TITLE: DA0239/2022 - 66 Peel Street West, West Launceston - Residential - Construction of a Dwelling and an Outbuilding

FILE NO: DA0239/2022

RE: DA0239/2022 - PROPOSED RESIDENCE
66 Peel Street West, WEST LAUNCESTON 7250

DRAWING TITLE:
site & contour plan
1:200 @ 100% to A2

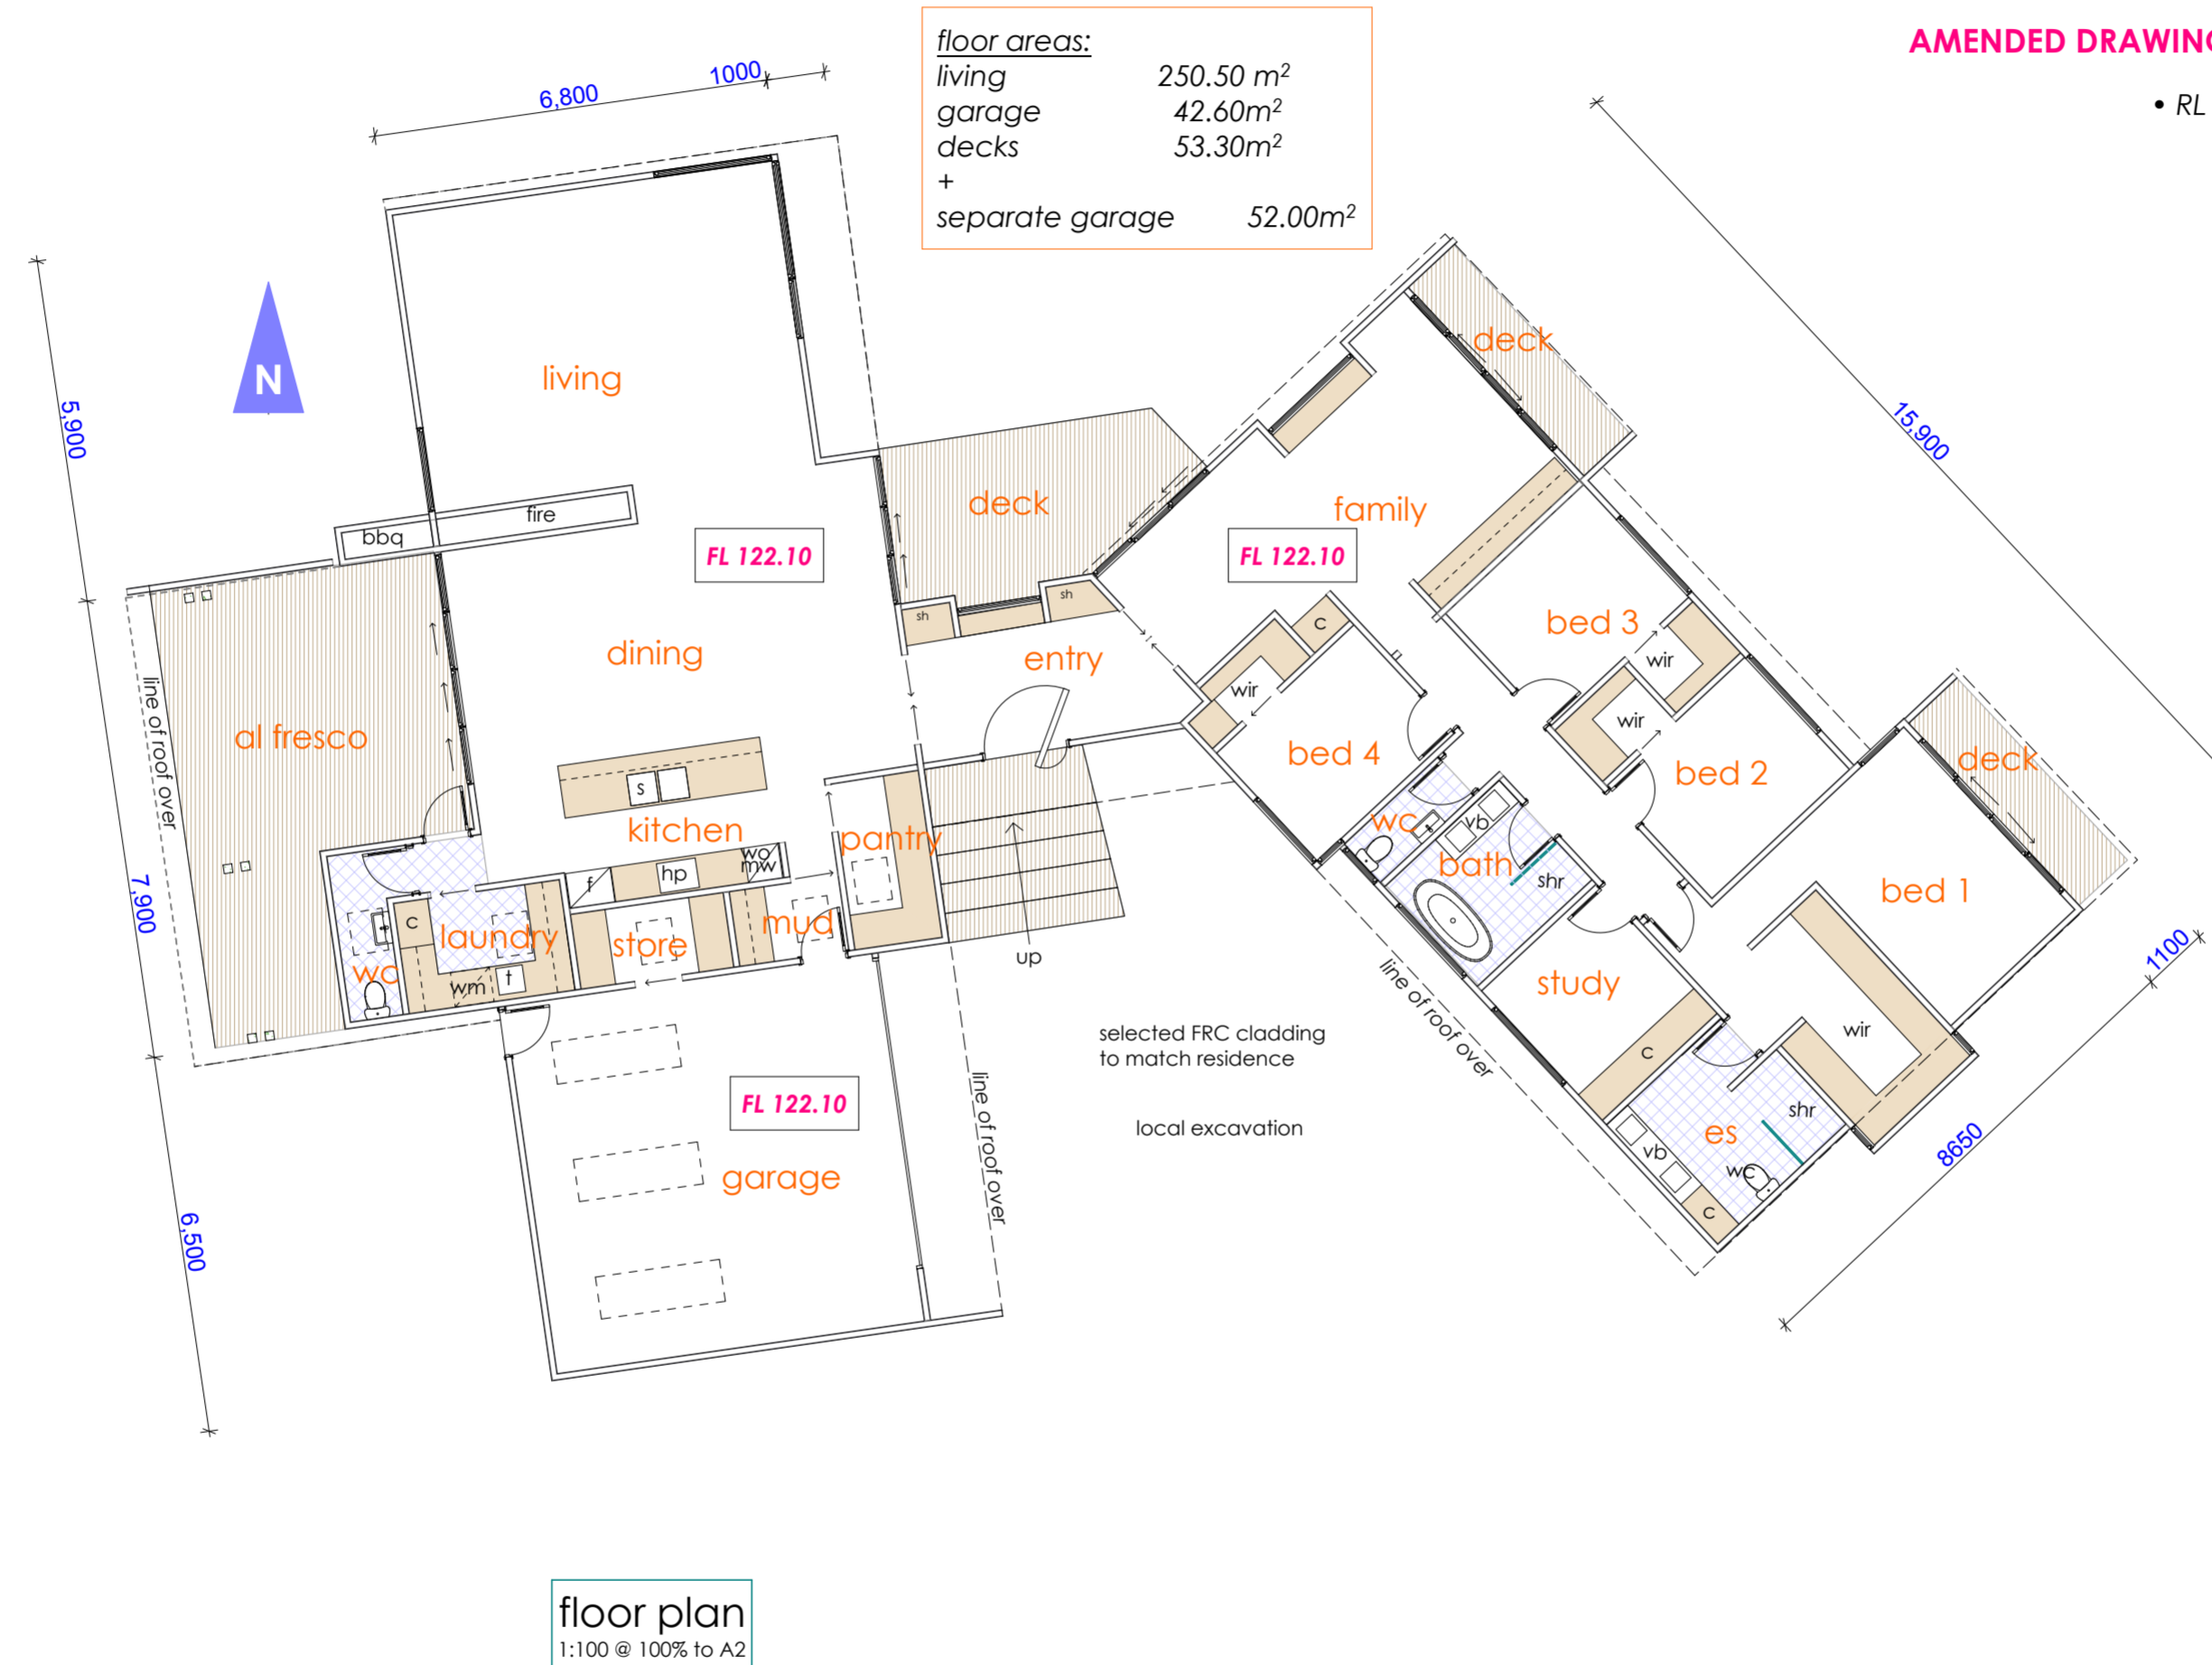
<p>A2 No vegetation is to be removed.</p> <p>Relies on Performance Criteria The proposal includes a removal of eight trees with variable sizes to facilitate the development. However, in response to representations received during the advertising period, the applicant agreed to reduce the number of trees to be removed to six. This will be conditioned in the planning permit. The proposal relies on performance criteria.</p>
<p>P2 Development that involves only the clearance or removal of vegetation must have regard to:</p> <ul style="list-style-type: none"> (a) the scenic management precinct existing character statement and management objectives in clause E7.6.3; (b) the physical characteristics of the site; (c) the location of existing buildings; (d) the type and condition of the existing vegetation; (e) any proposed revegetation; and (f) the options for management of the vegetation.
<p>Complies As described under E7.6.2 (P1), subject to a condition on the planning permit, the development will include the removal of six trees in variable sizes and the retention and maintenance of 4 mature trees located on the site. The trees proposed to be removed are located within or near the proposed building area. As the subject site is located within the Bushfire Prone Area overlay of the Launceston Interim Planning Scheme 2015 and having regard to the location of buildings and safety concerns the proposed tree removal is considered reasonable. In addition, there will be a site landscaping with boundary screen planting with non- combustible species as part of fire hazard management plan as specified in the plans. The proposal is deemed to comply.</p>

Clause 8.1.3 - revised site plan including tree removal, FFL to elevations

- groundwater and stormwater cutoff drains & kerbs directing to street outlet - refer site plan for details
- potential for loss of topsoil or soil erosion is mitigated by generous landscape buffer between excavation and rear title boundary which also provides opportunity for 'green' privacy from uphill property

- revegetation of the site will be in strict accordance with considered selection of species for safest inclusion in such an area - refer site plan for extent of options for appropriate landscaping

floor plan
1:100 @ 100% to A2

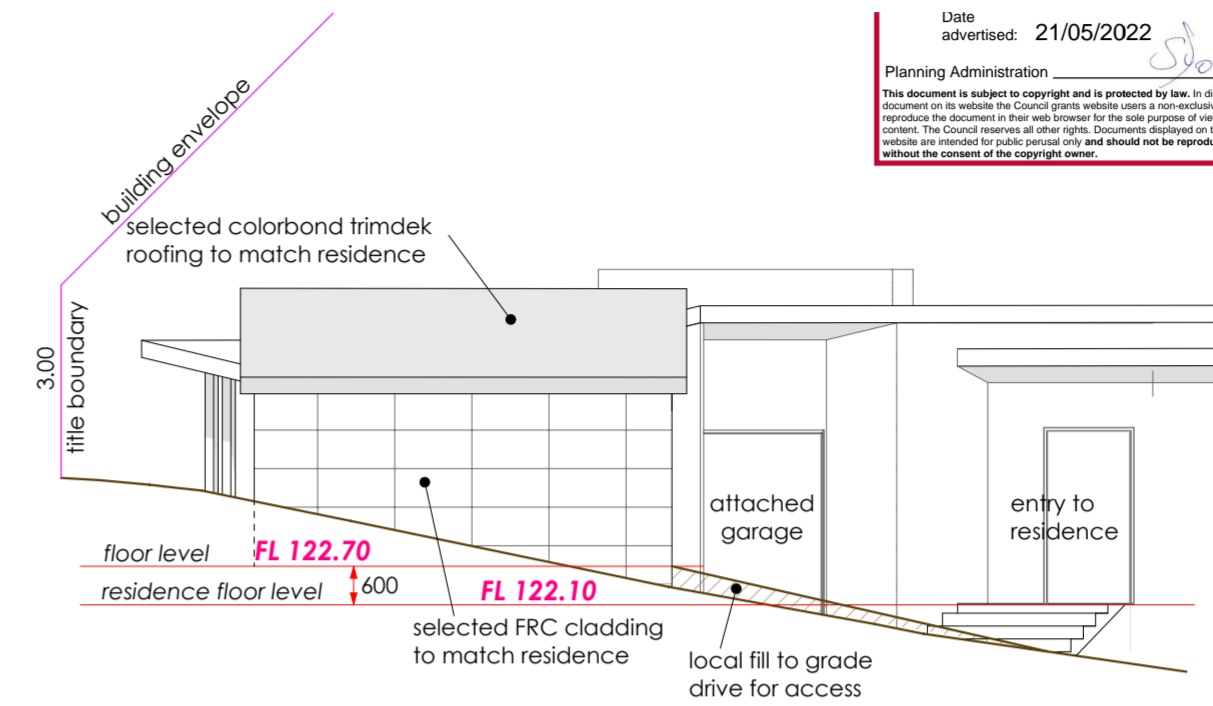
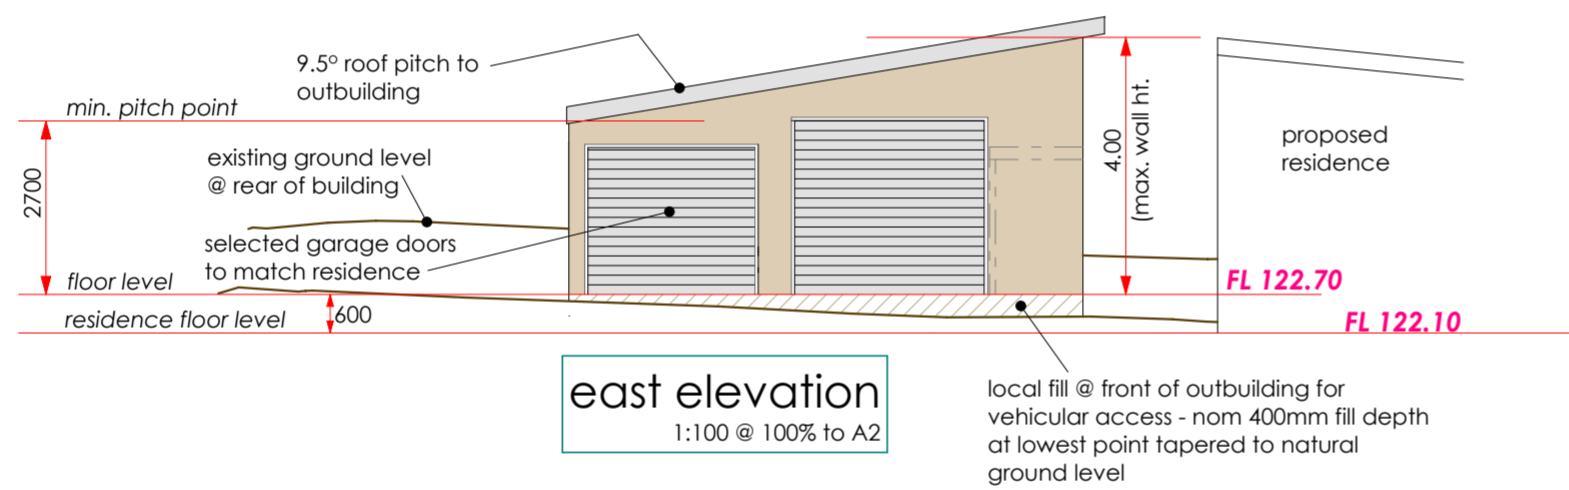
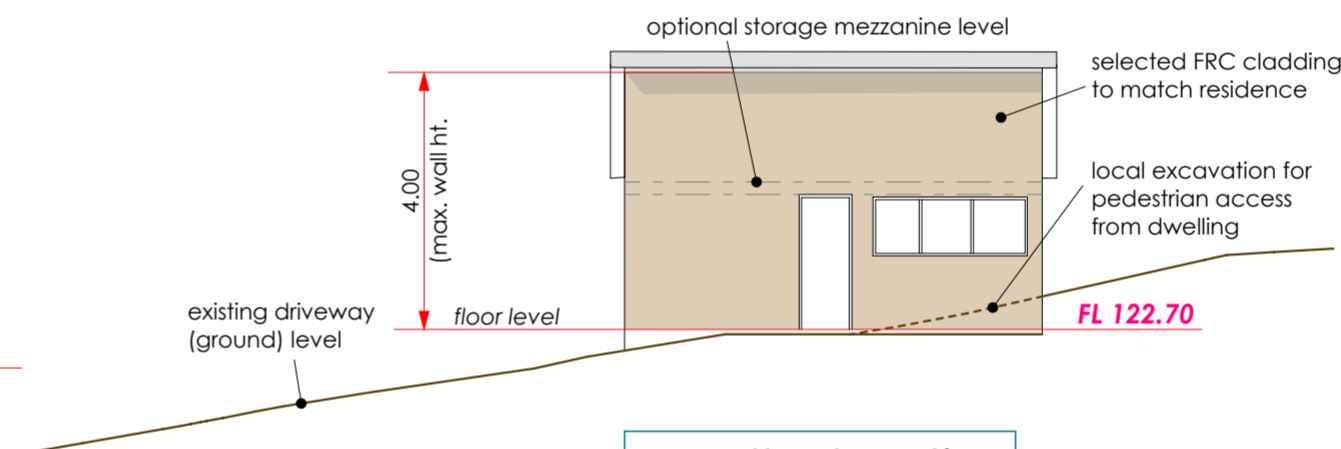
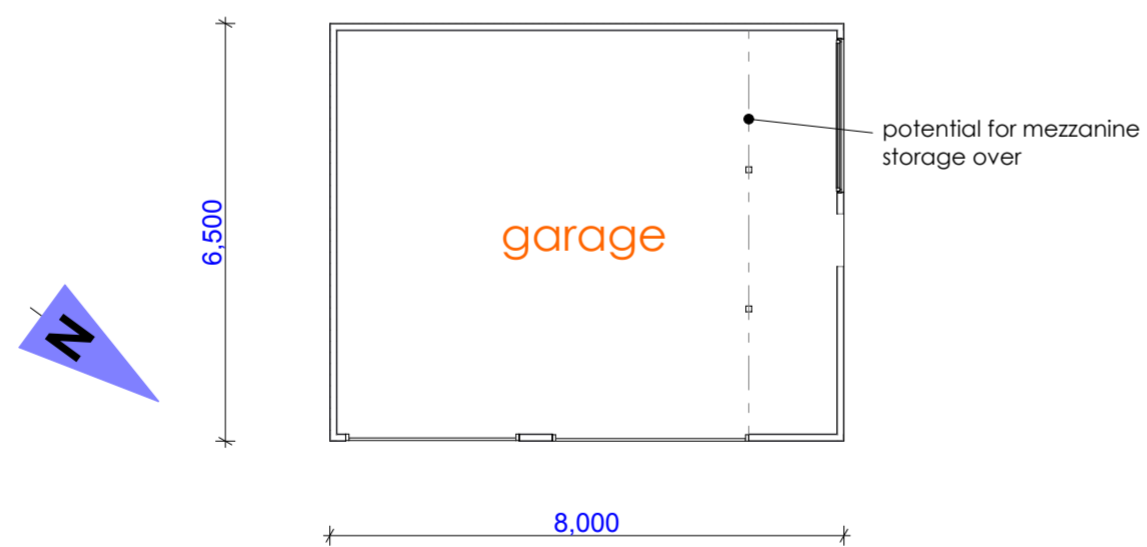
The floor area of the proposed outbuilding is 52m². The proposed wall height is 4m and the building height will be 4.3m. As such the proposal relies on the performance criteria.

1. Outbuildings

- RL for floor added
- local driveway fill shown
- maximum wall height reduced
- roof pitch reduced to 9.5°

- visual impact from street - located as close to sw corner as possible of internal lot - partially recessed into bank to minimise height so below that of the proposed dwelling - roof height pitches towards residence to maintain low profile at end of driveway
- no impact to native vegetation but removal of two mature fruit trees
- height + wide setbacks from boundary pose no threat of overshadowing to adjoining properties
- only apparent outbuilding is uphill to rear of site - refer location plan
- proposed outbuilding = 52 sq m
- north wall only (closest to higher dwelling) = 4.00 metres high from slab
- 4.70 metres @ lowest ground level to apex of roof (north wall)
- submitted garage drawings reflect above dimensions - RL noted

- least setback is 2.20 from south west boundary
- proposed excavation intended to limit landscape retaining wall height @ rear of building to 1.00 and sufficient to enable pedestrian access around the building
- .80 metre maximum height of retaining wall to outbuilding forms actual building wall to minimise impact adjacent drainage easement and minimise visual height above ground
- 1.75 closest point to registered easement on site
- topography of site encourages locating at rear where minimal site works required for driveway/access infrastructure in combination with proposed residence
- outbuilding excavation is required in association with residence where minimal excavation is proposed to balance height of buildings and provide sensible pedestrian and vehicular access
- no adjoining structures exist to be impacted
